STRUCTURE GENERAL NOTES BRIDGE NO. SUM-00082-00.000 OVER CUYAHOGA RIVER, CVSR RAILROAD, BIKE PATHS	
FILE: \$FILEABBF	SFN 7706871 DESIGN AGENCY

STRUCTURE DETAILS PIER 1 LEFT (OUTSIDE)
updated	SFN 7706871 DESIGN AGENCY DESIGNER CHECKER MJA CHECKER MJA TJP REVIEWER TJP 10-03-23 PROJECT ID REVIEWER TJP 10-03-23 PROJECT ID 107247 SUBSET TOTAL 19 29 SHEET TOTAL 19 29 SHEET TOTAL 19 34

ITEM 513 – STRUCTURAL STEEL, MISC.: STEEL PLATE CONFINEMENT ASSEMBLY

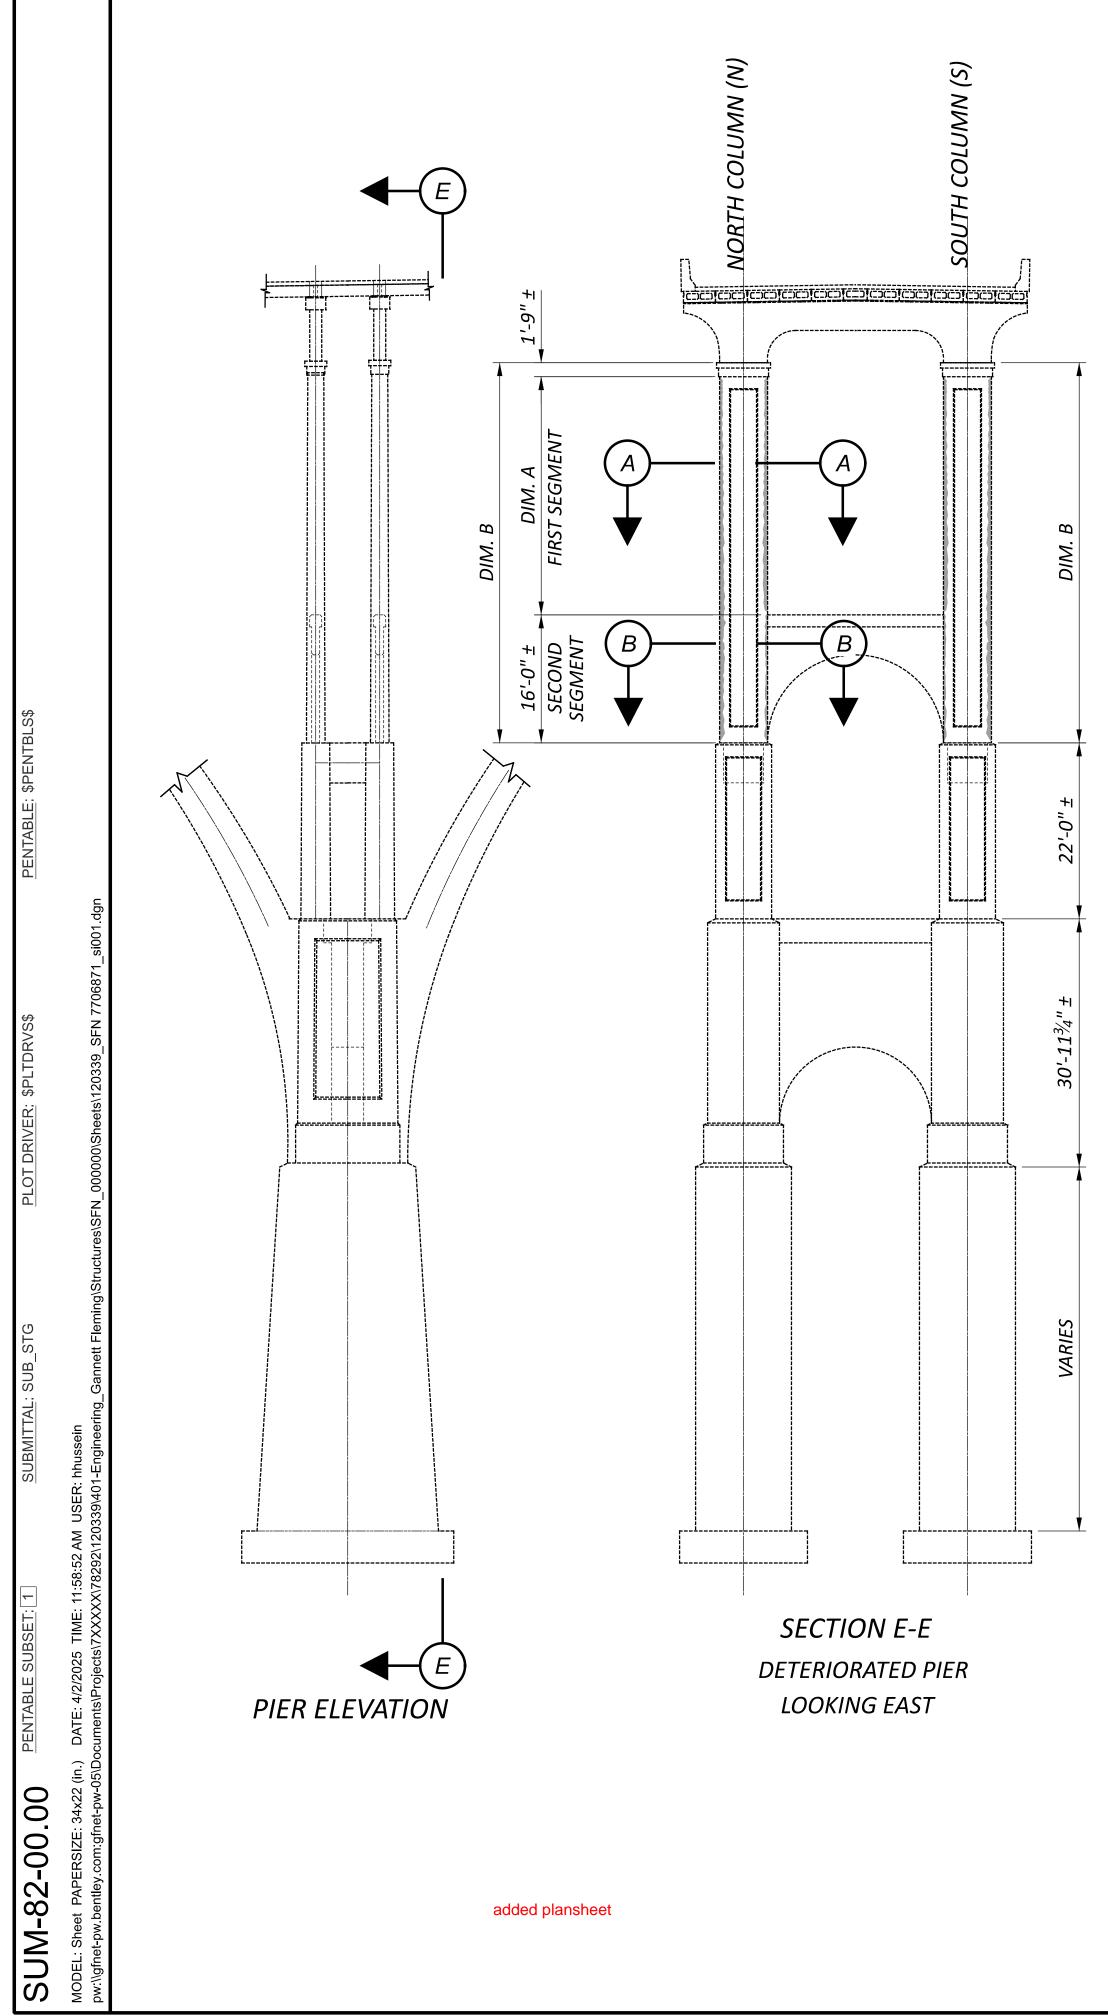
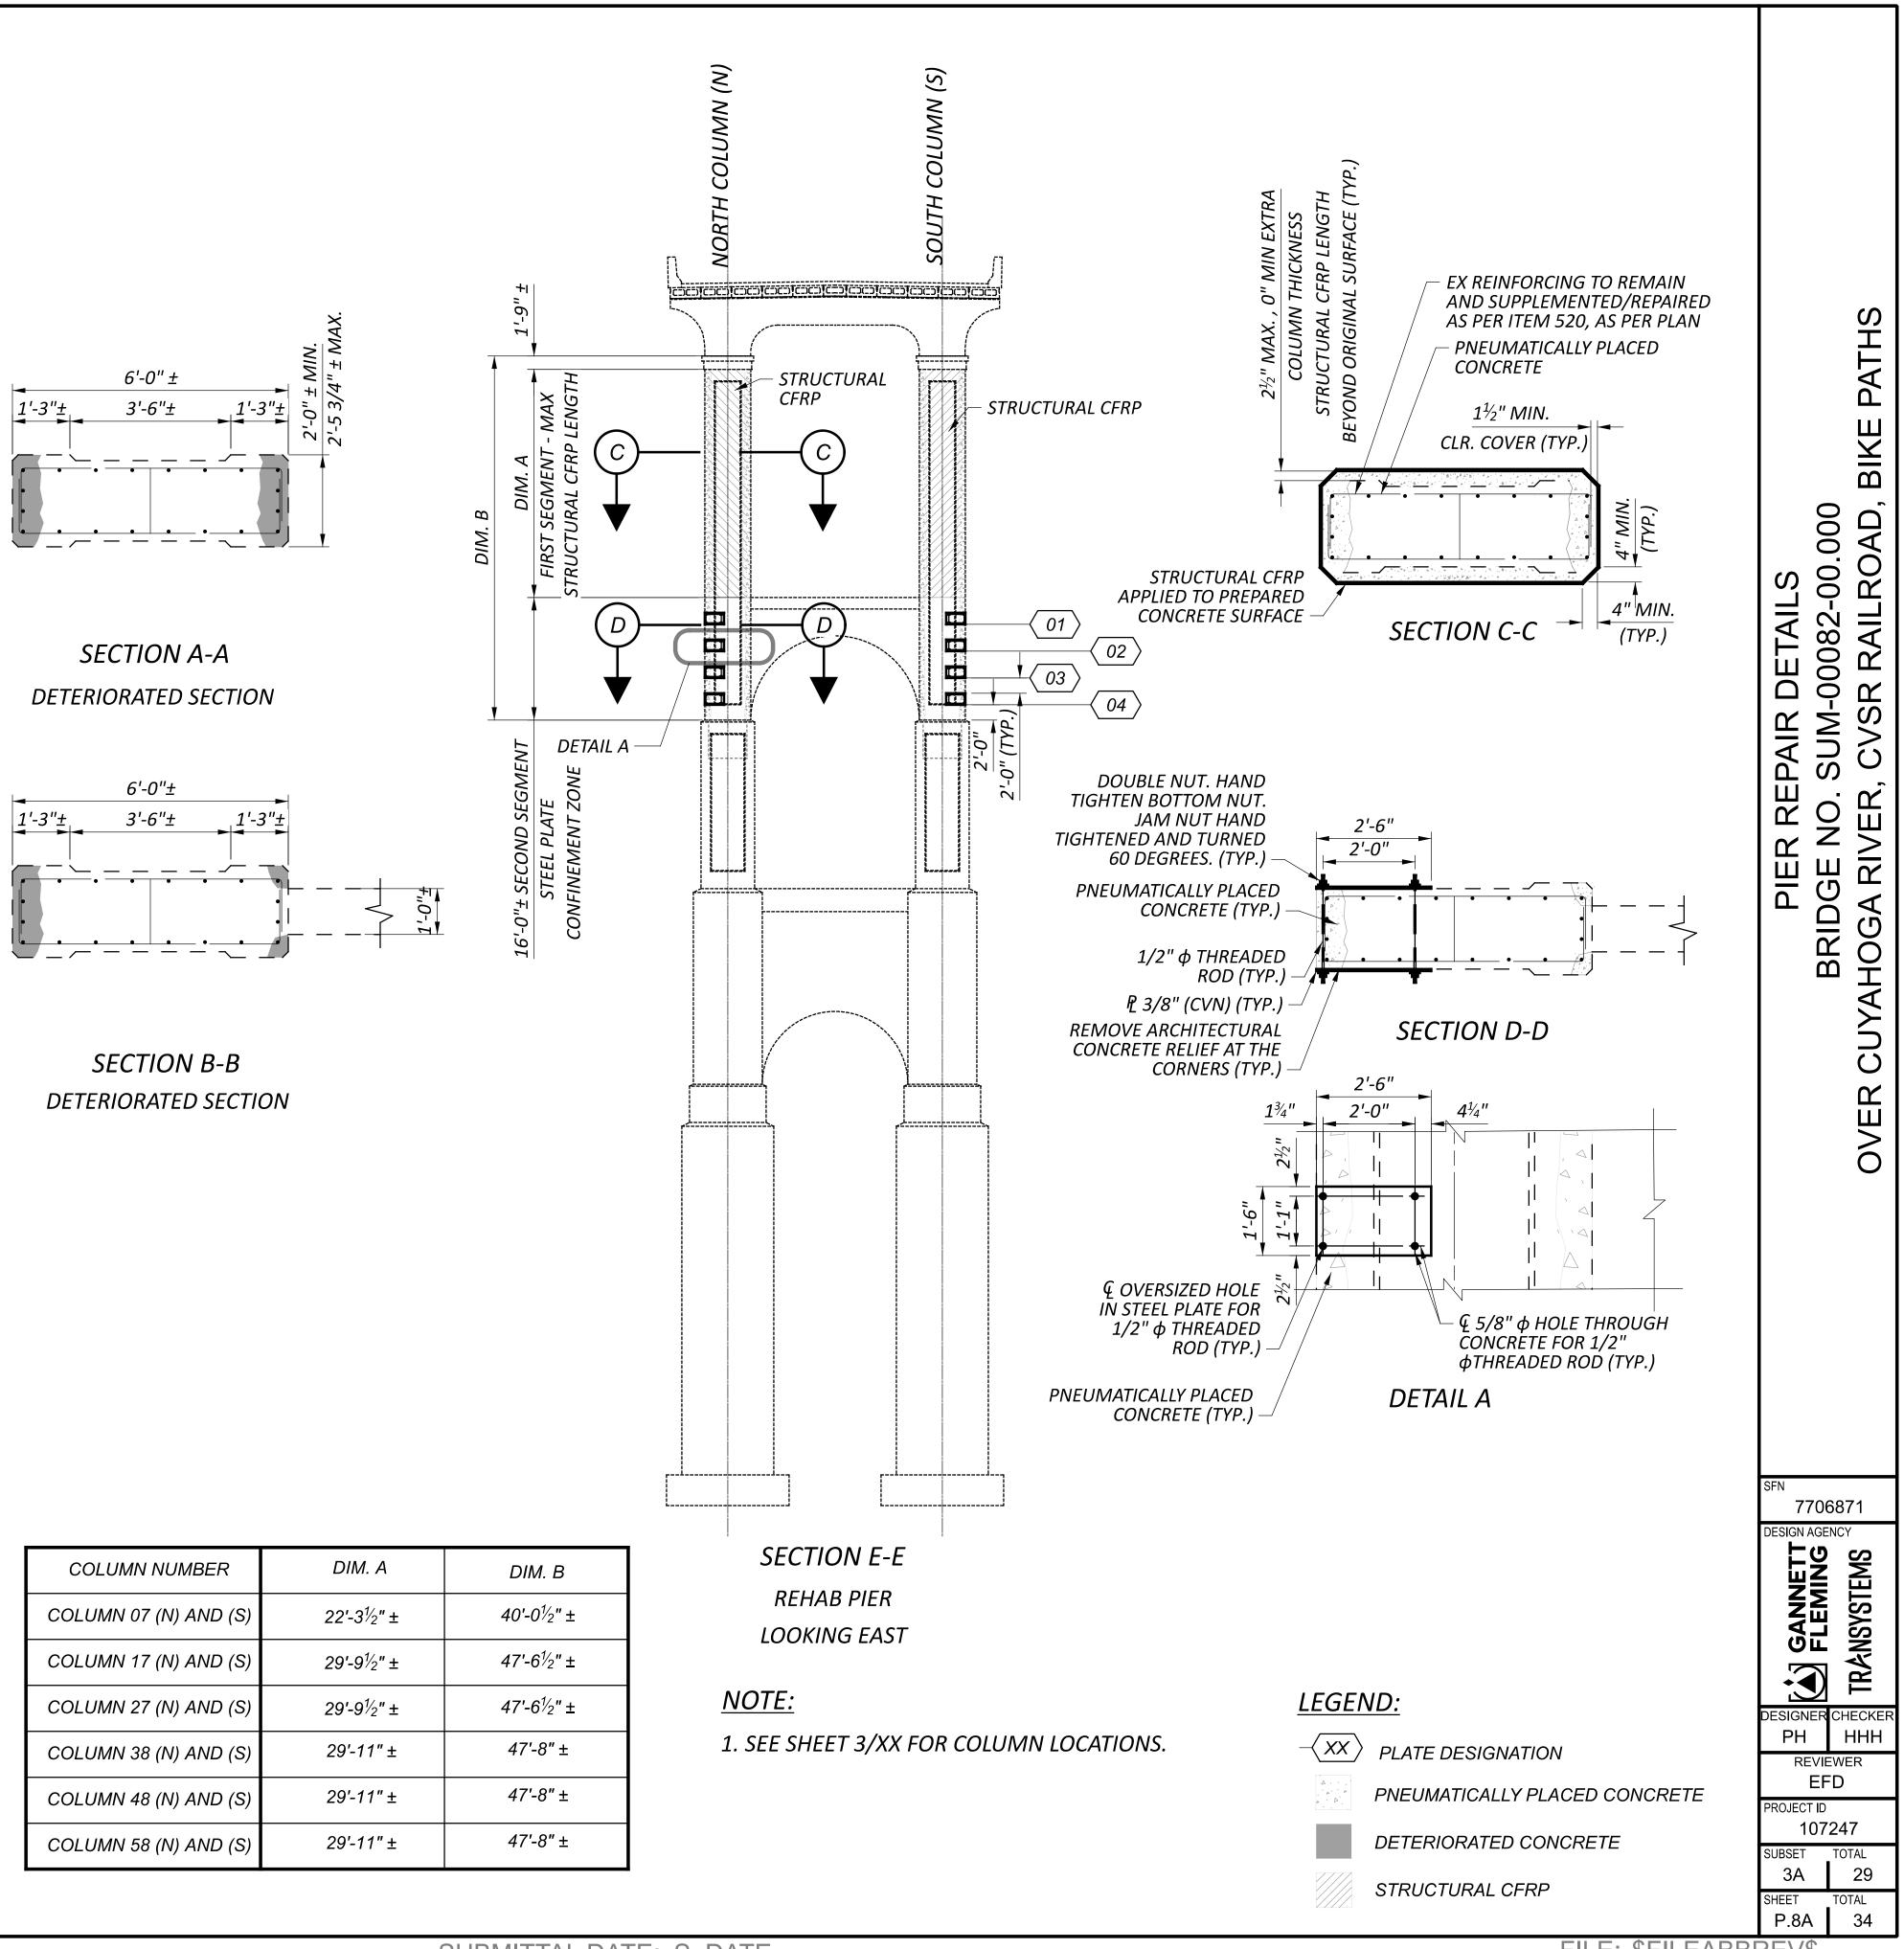
IN ADDITION TO THE REQUIREMENTS OF ITEM 513, THIS WORK CONSISTS OF FURNISHING AND FABRICATING STEEL PLATES. FURNISHING AND INSTALLING THREADED RODS AND ASSOCIATED NUTS AND WASHERS, PREPARING THE EXISTING CONCRETE SURFACES, LOCATING THE EXISTING PIER COLUMN REINFORCING, DRILLING HOLES THROUGH THE EXISTING PIER COLUMNS, AND COMPLETING THE INSTALLATION OF ALL STEEL CONFINEMENT COMPONENTS. THIS WORK ALSO INCLUDES PROVIDING THE NECESSARY LABOR, MATERIALS, AND EQUIPMENT TO ACCESS THE

THE EXISTING ARCHITECTURAL REVEAL/EXTENSION AT THE COLUMN CORNERS SHALL BE REMOVED TO PROVIDE A UNIFORM BEARING SURFACE FOR THE STEEL CONFINEMENT PLATE. ALL SOUND AND UNSOUND CONCRETE SHALL BE REMOVED TO PROVIDE A UNIFORM BEARING SURFACE FOR THE STEEL PLATES. REMOVAL SHALL BE INCLUDED IN THE COST OF THIS REPAIR AND SHALL BE PERFORMED AS PER CMS 520.08. AS DIRECTED BY THE ENGINEER, USE A BUSHHAMMER OR GRINDER FOLLOWED BY A THIN FILM OF PORTLAND CEMENT MORTAR OR PASTE TO PROVIDE A

FURNISH THREADED RODS, NUTS, AND WASHERS PER CMS 711.09. THREADED RODS, WITH A HEAVY DUTY WASHER AND TWO NUTS ON EACH END, MAY BE REPLACED BY ASTM F3125, GRADE A325, BOLTS

ALL STEEL PLATES, THREADED RODS, NUTS, WASHERS, AND OTHER STEEL COMPONENTS SHALL BE GALVANIZED PER CMS 711.02.

PRIOR TO FIELD DRILLING HOLES THROUGH THE PIER COLUMNS AND FABRICATING THE STEEL PLATES, LOCATE THE EXISTING REINFORCING STEEL IN THE VICINITY OF THE PROPOSED HOLES TO VERIFY THE DRILLING OPERATION WILL NOT DAMAGE THE EXISTING REINFORCING. IF EXISTING REINFORCING STEEL INTERFERES WITH A PROPOSED HOLE LOCATION AND FIELD-FABRICATING HORIZONTAL, LONG SLOTTED HOLES PER AISC TABLE J3.3 IN THE PLATE WILL NOT ACHIEVE A PROPER FIT, A NEW GALVANIZED STEEL PLATE SHALL BE FURNISHED TO FIT THE REVISED HOLE PATTERN AT NO COST TO THE DEPARTMENT. THE FIELD-DRILLED HOLES THROUGH THE PIER COLUMN SHALL NOT BE MORE THAN 1/8" LARGER IN DIAMETER THAN THE THREADED ROD.

AFTER INSTALLATION OF THE STEEL PLATE CONFINEMENT ASSEMBLIES HAS BEEN COMPLETED AND ACCEPTED, APPLY PNEUMATICALLY PLACED CONCRETE (SHOTCRETE) IN THESE AREAS TO COVER ALL EXPOSED EXISTING REINFORCING STEEL AND THE OUTER THREADED RODS OF THE STEEL PLATE CONFINEMENT ASSEMBLY. FIFTY-EIGHT (58) SQUARE FEET OF STRUCTURAL PNEUMATICALLY PLACED CONCRETE HAS BEEN INCLUDED IN THE ESTIMATED QUANTITY FOR ITEM SPECIAL – STRUCTURES: STRUCTURAL PNEUMATICALLY PLACED CONCRETE (SHOTCRETE) FOR EACH STEEL PLATE CONFINEMENT ASSEMBLY.
